R22 Arrivals Off-set Request for Information

DRAFT - Motion to send a formal request for information and action items to MPA, FAA, MIT and/or any of its consultants to provide the following information to the Massport CAC within 30 days in order to provide more transparency and necessary insight for communities that will be impacted by the FAA flight path proposal known as 2-A1 22L:

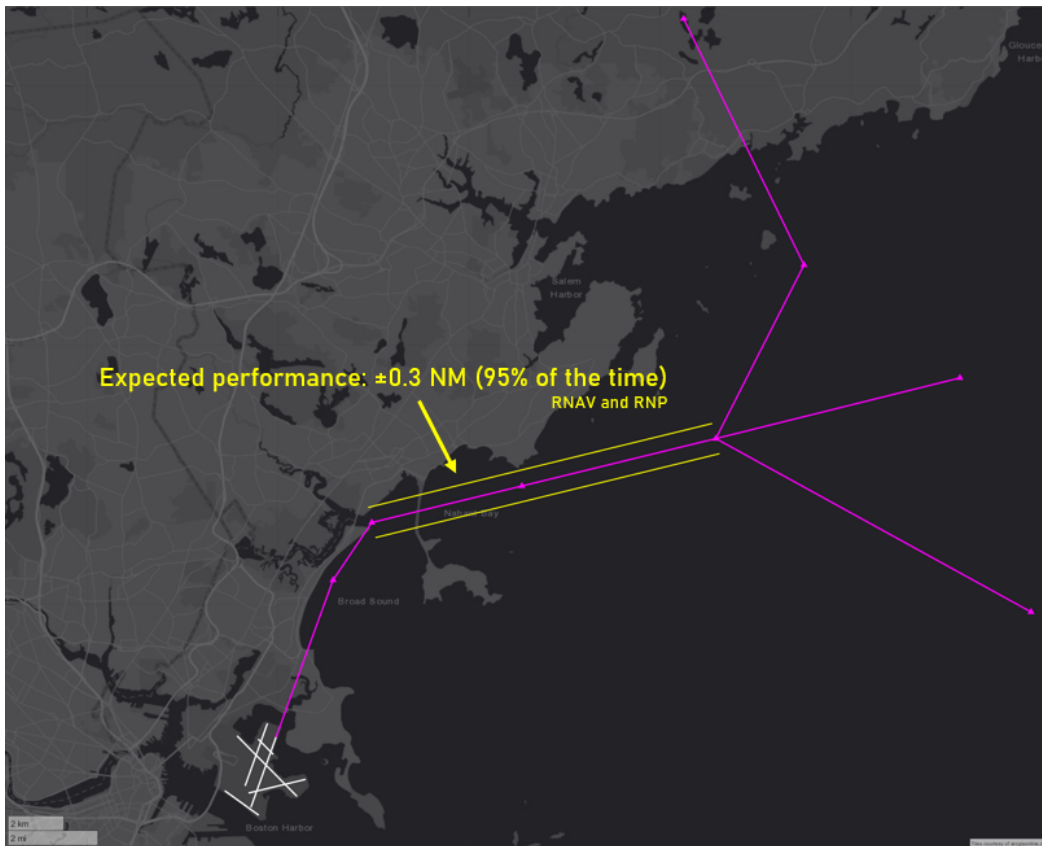
- Altitudes along current flight path and proposed flight path;

- Analysis of 2019 base line for all Logan airport arrivals along with analysis of arrivals that could have used the proposed off-set including time and day of operation. Include separate analysis of hypothetical use by only RNP equipped aircraft;

- Will be addressed in Block 2 report
- Provide GPS listening post coordinates from centerline of R22 arrival that were used to simulate the noise impact at the new GPS coordinate on Nahant Road in order to enable residents of Lynn, Swampscott, and Nahant, to experience the real noise impact;

- A simulation of the flight track dispersion of the proposed flight path over Nahant Road that includes the center line and boundaries;

- Documentation on how the ATC will use the proposed flight path including, specific hours of operation, volume, weather conditions, restrictions on use, etc.; and
- Will be addressed in Block 2 report
- A written proposal requiring the FAA to conduct a test prior to any acceptance similar to the jetBlue light visual over Boston Light to Runway 33.
- Not within scope of the project.

- Written support or data justifying the rationale for no RNP. RNP only was requested. RNP only procedure off-set to existing RNAV/ILS for R33L arrivals is being adopted;

- RNAV and RNP have identical lateral accuracy performance. Procedure does not require turn to final outside the RNAV criteria so RNAV and RNP overlay procedures will have the same tracks.

- Will be addressed in Block 2 report
- All back-up data used in the requested analysis;
- Beyond scope.
- Probability of use - high, medium, low, and weather conditions for said recommended path;

- Analysis conducted at 0.1 NM grid resolution
